**ROCK HARBOR COMMERCIAL WHARF IMPROVEMENTS
TOWNS OF ORLEANS, MA
ADDENDUM #3**

PROJECT: Rock Harbor Commercial Wharf Improvements

DATE: March 22, 2024

CONSULTING ENGINEER: Foth Infrastructure & Environment, LLC
15 Creek Road, Marion, MA 02738

A SHEET PILE BULKHEAD SECTION AT COMMERCIAL LANDING PIER
SCALE: 1" = 1'

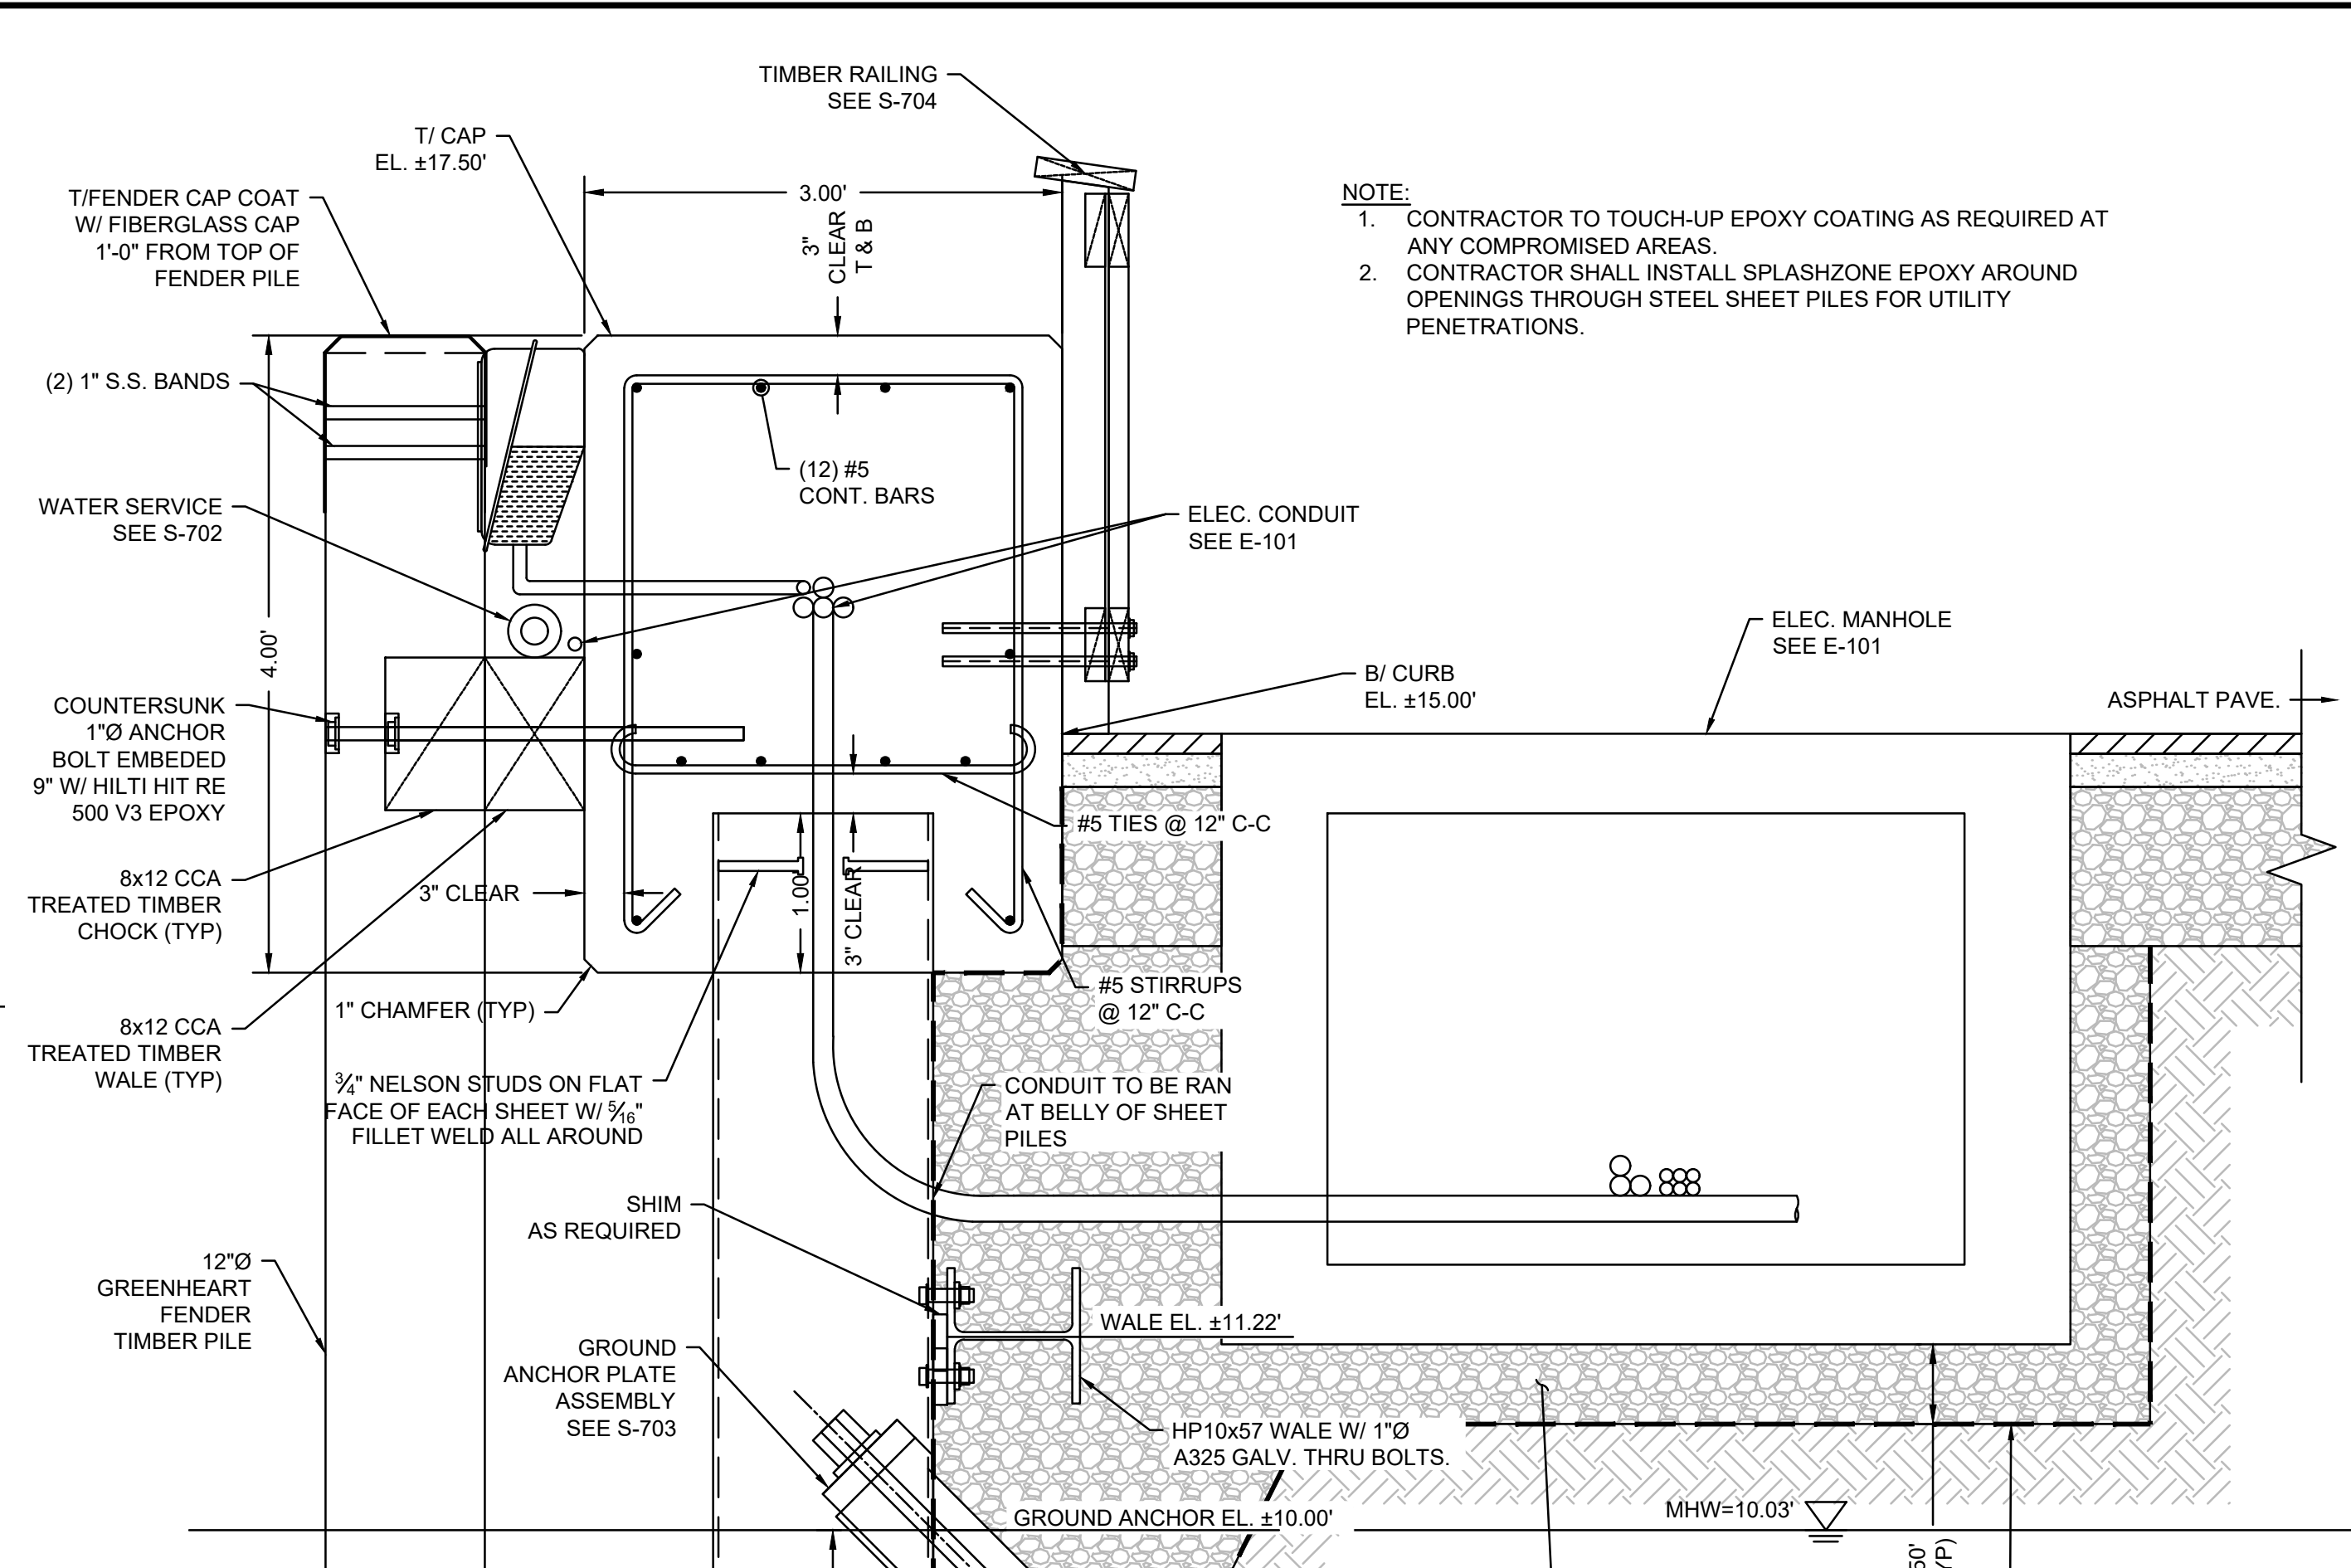
12. *Is there a grout joint or deck Panel shear key in between the precast deck planks? If so, please provide detail for the grout joint in between precast deck planks.*

53. Reference drawing S-504, "Pile Plug Detail", note 4. Are the pile plug plates that the Contractor is responsible for have a PE design intended to be structural plates or simply temporary form plates to support the weight of the concrete plug until it reaches design strength?

RESPONSE: See Precast Plank Joint Detail added to sheet S-504 attached herein.

RESPONSE: See sheet S-504 attached for revised note with reference to PE requirement removed. The plug plate shall be sized as shown on the drawing, but the installation means and methods will be the responsibility of the Contractor. The intent of the plug plate is a bottom form for temporary support of the concrete during installation of the pile plug.

GANTRY BEAM DETAIL
SCALE: 1" = 2"

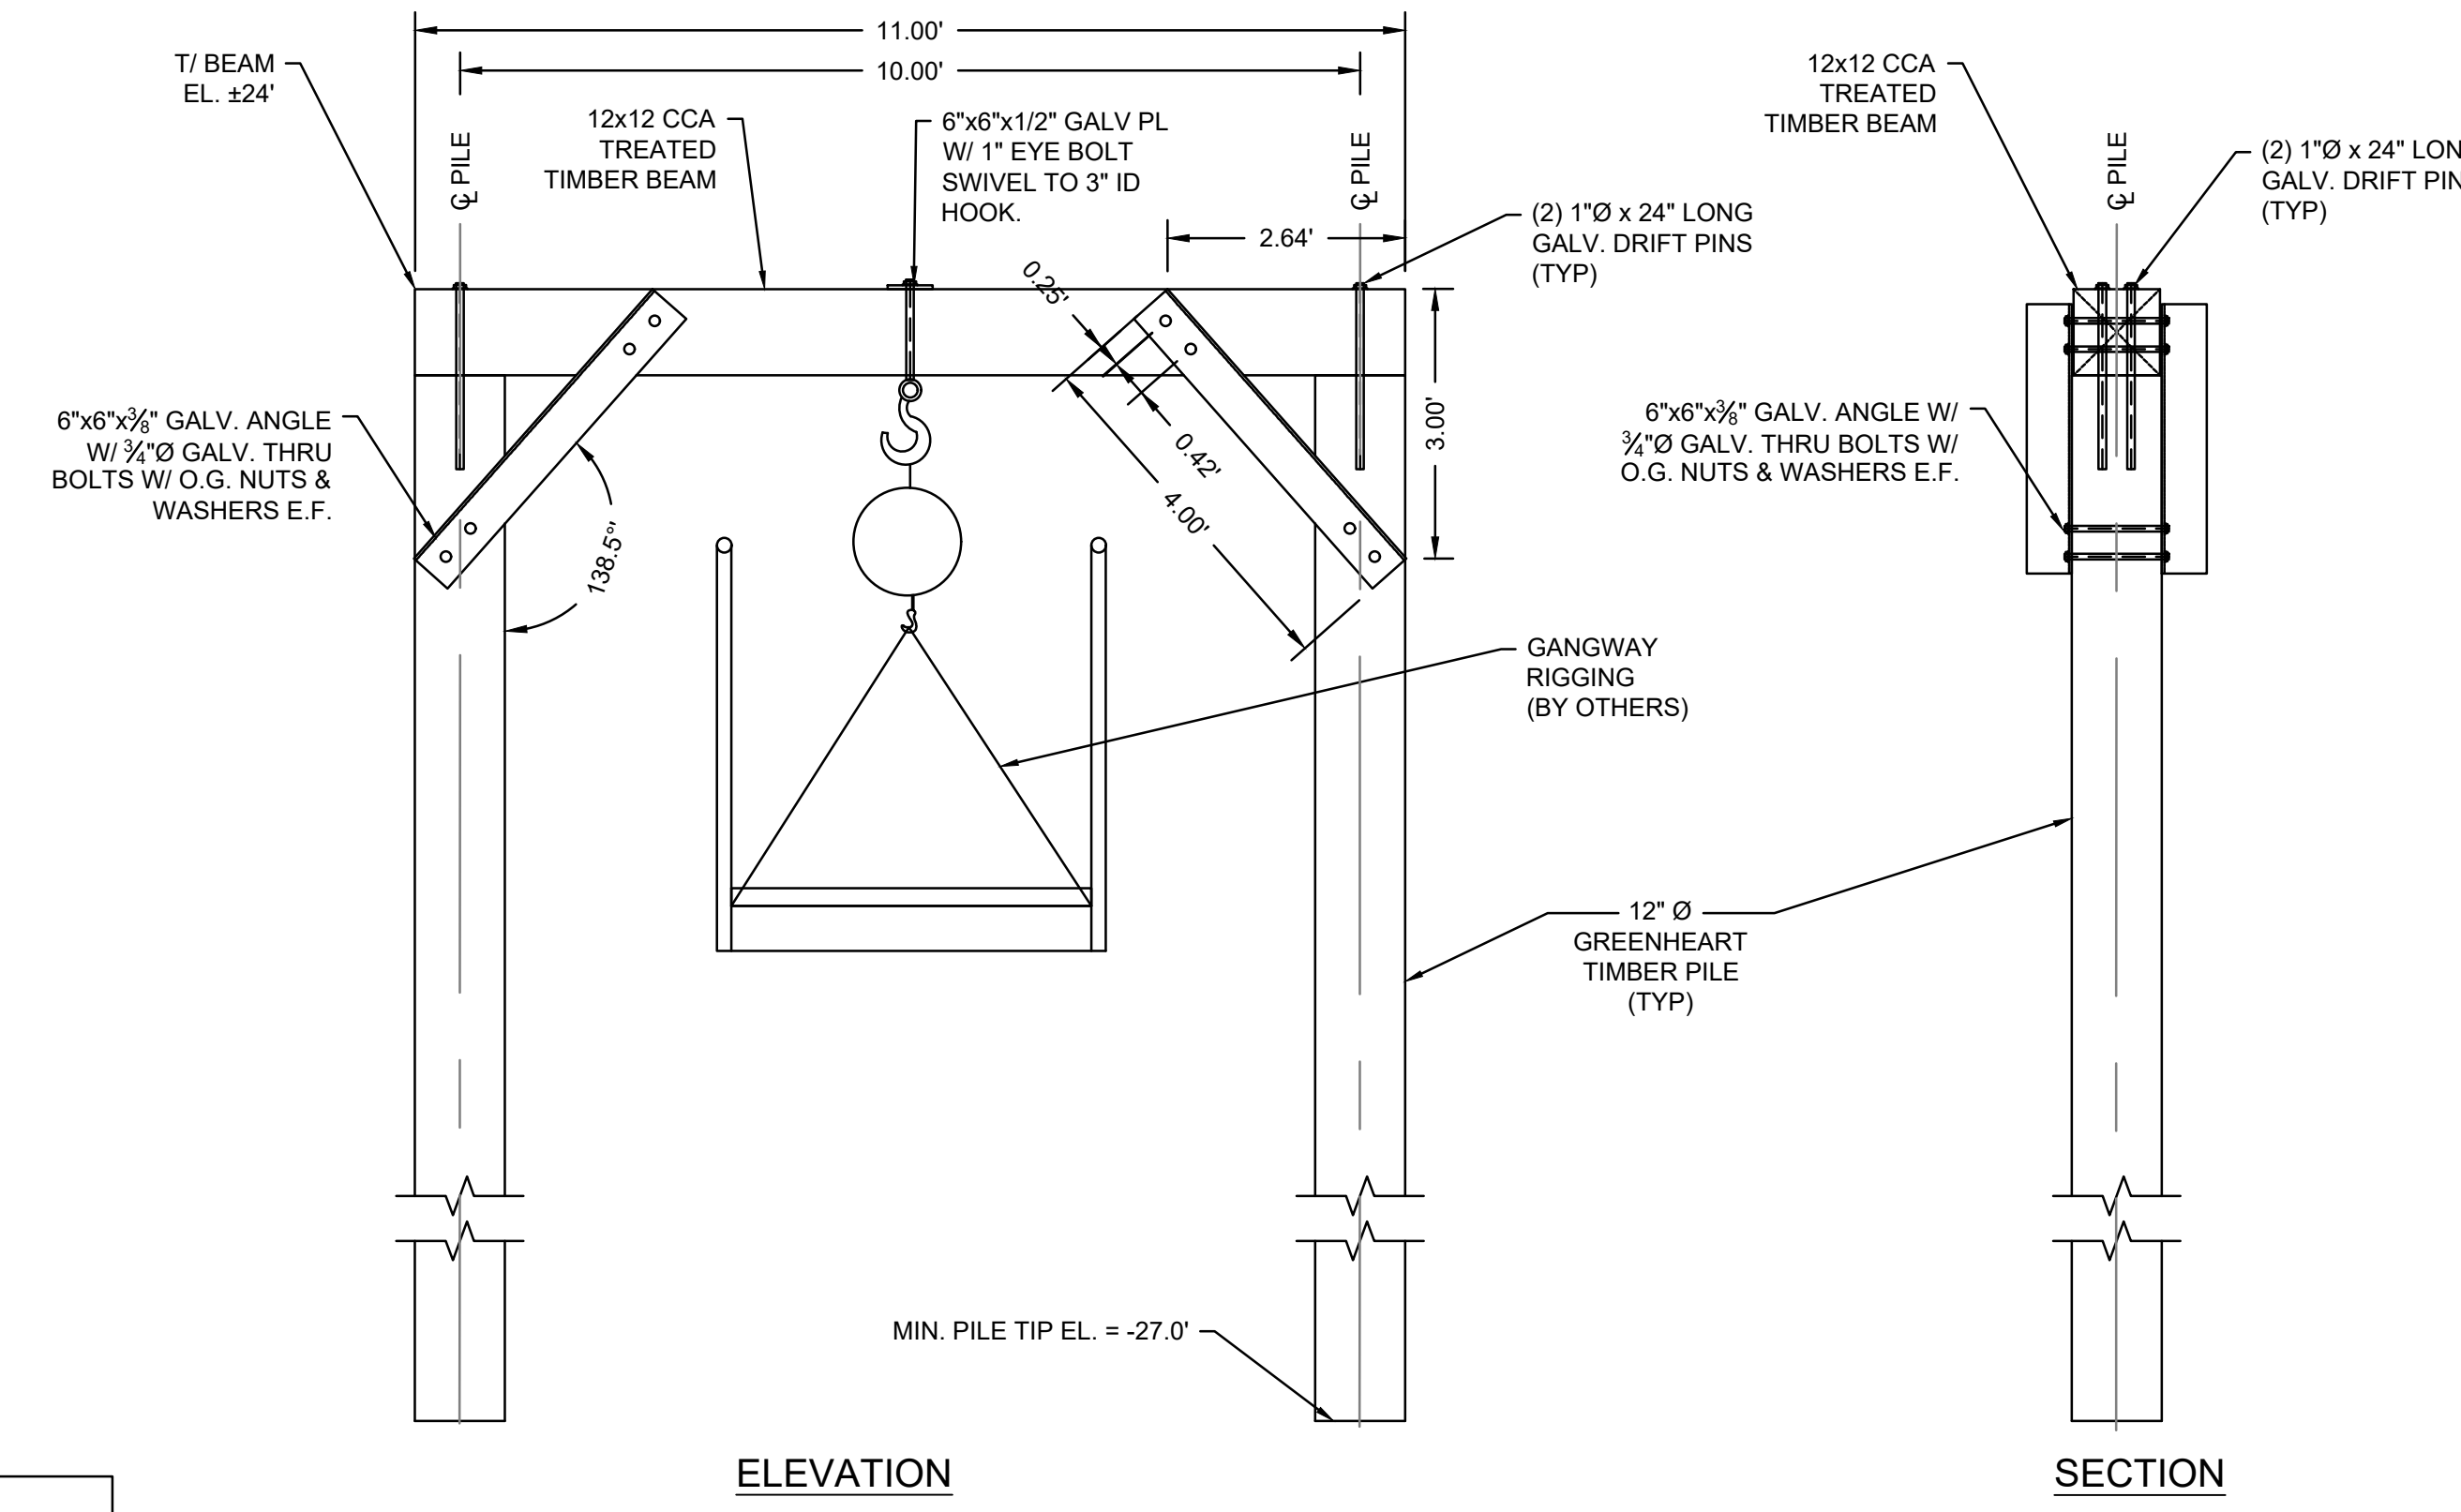
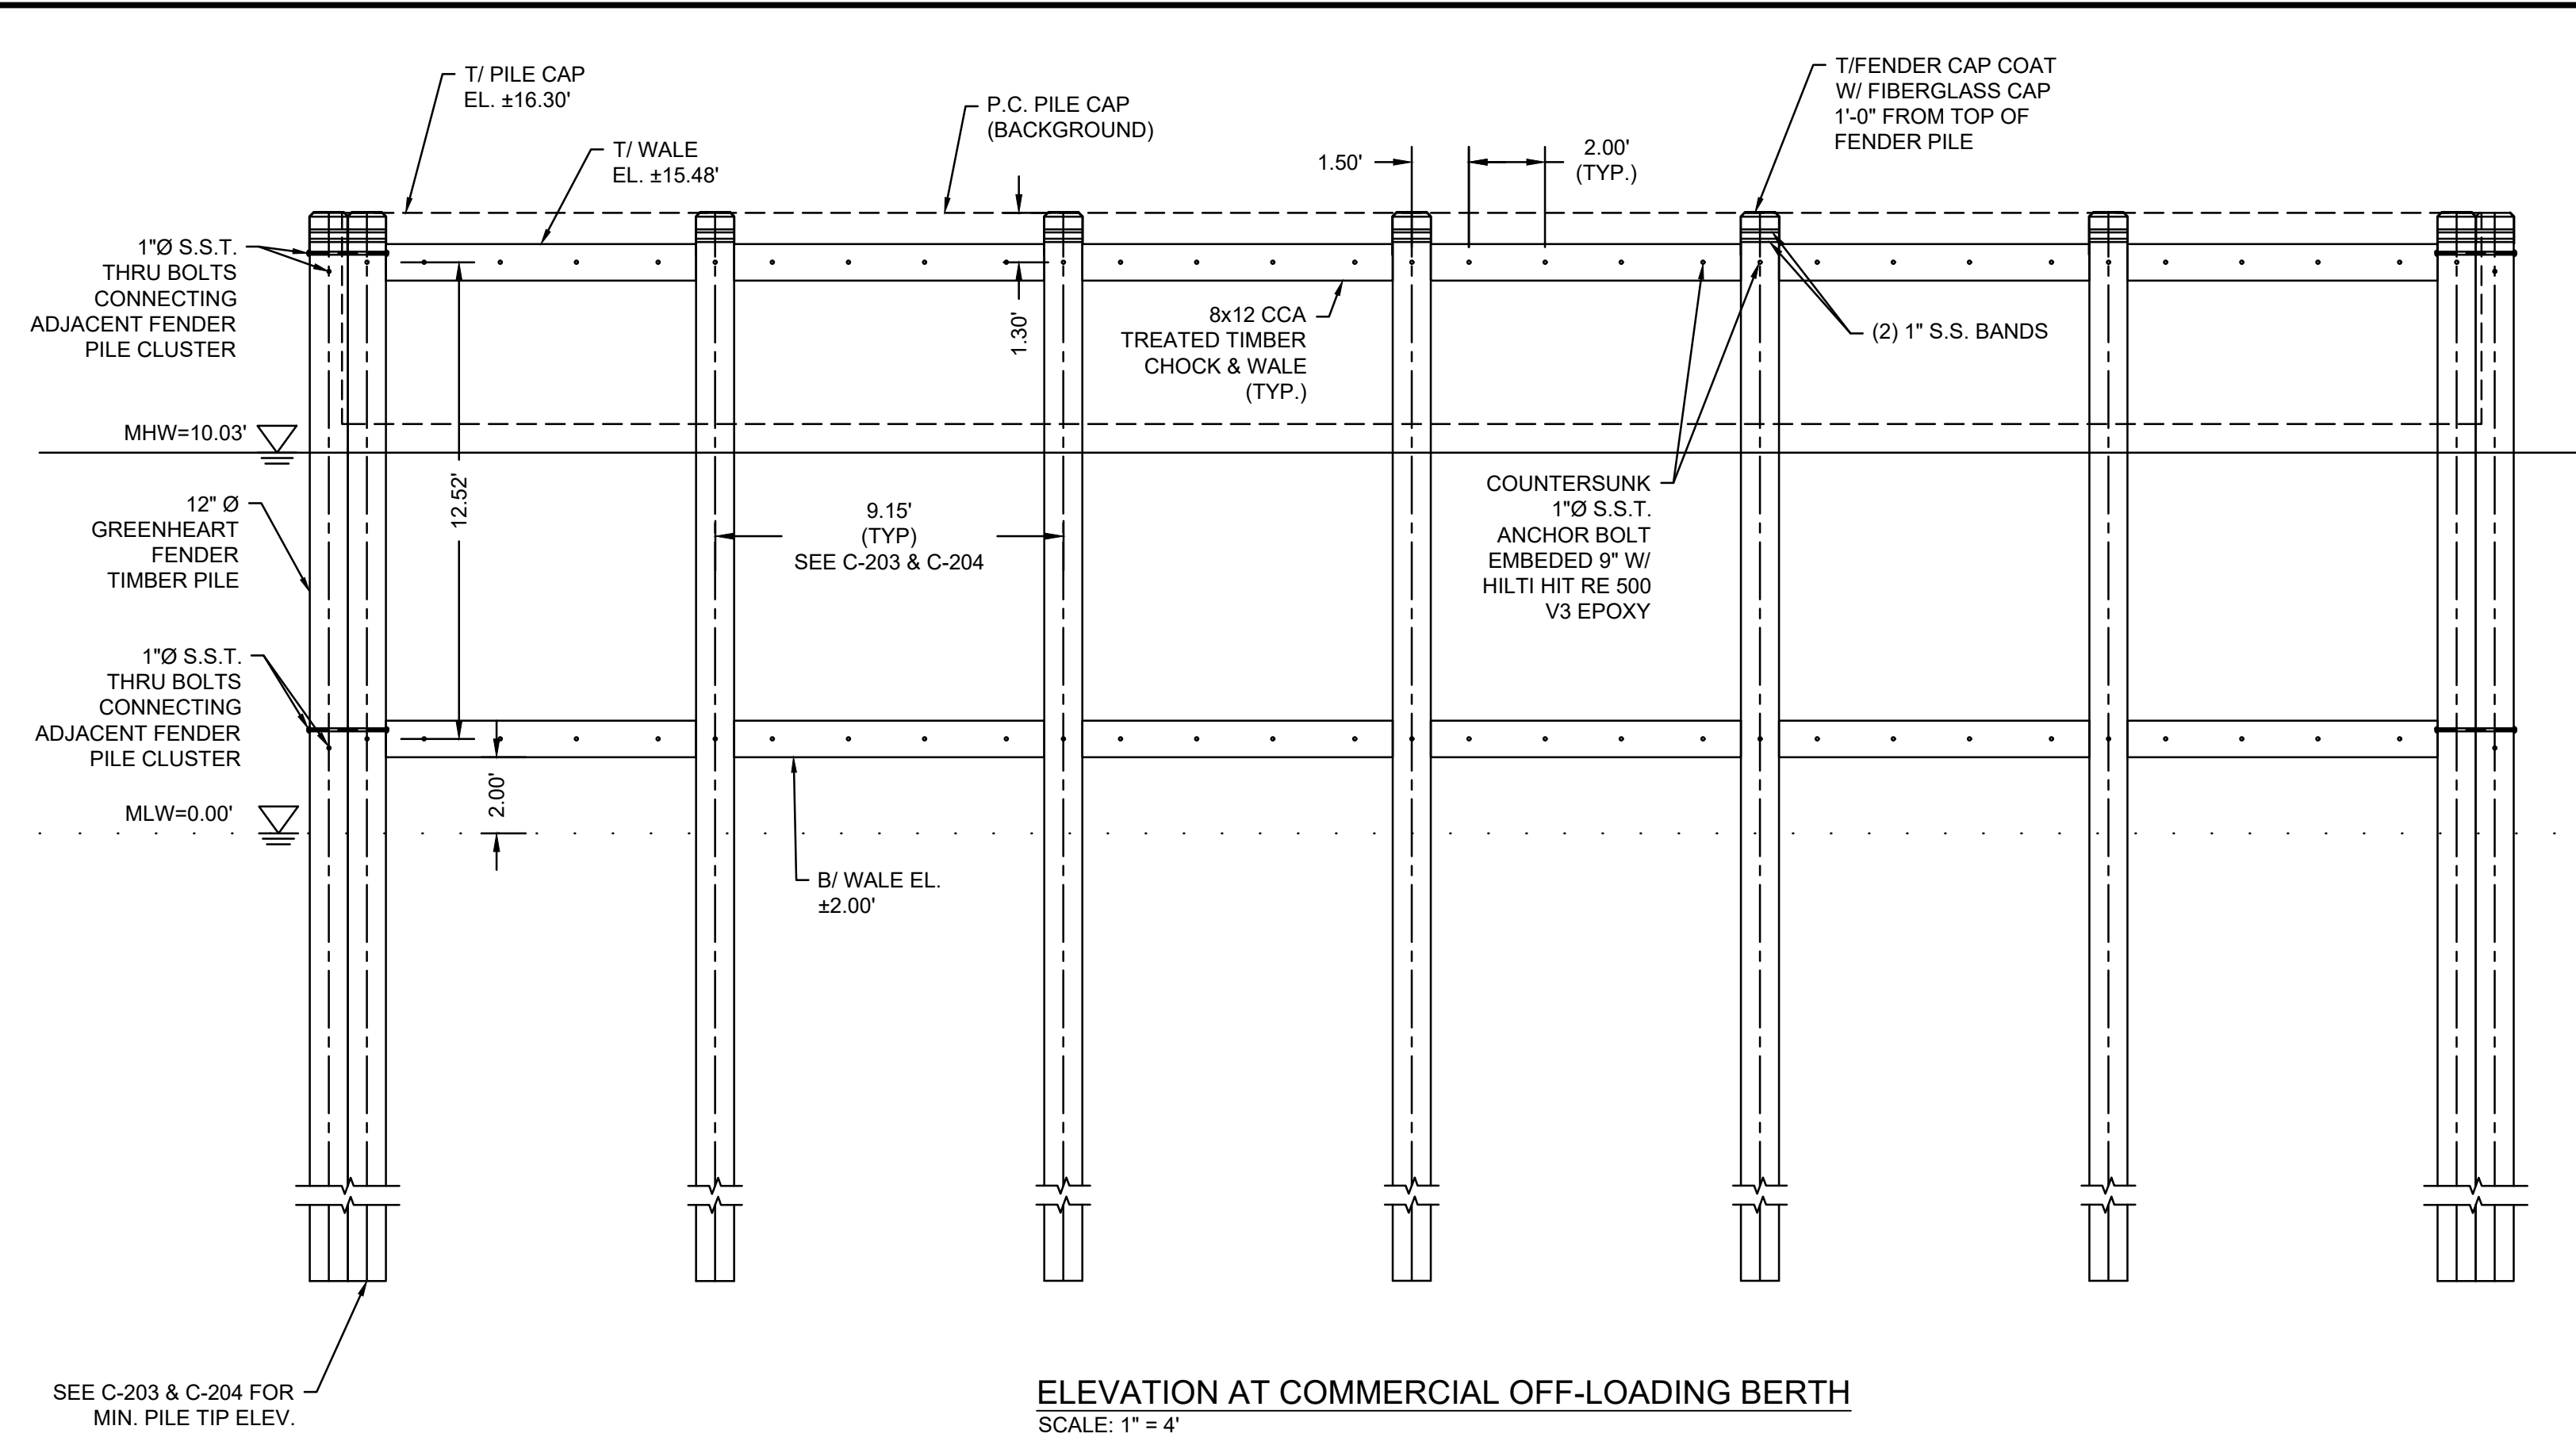
11. *Referring to drawing S-702 Gantry Beam Detail, please clarify who is responsible to furnish and install the winch and the hook above the winch?*

RESPONSE: The Contractor is responsible for furnishing and installing the beam, angle bracing, eye bolt, and hook. Rigging below the eyebolt will be provided by Owner as shown on the drawing.
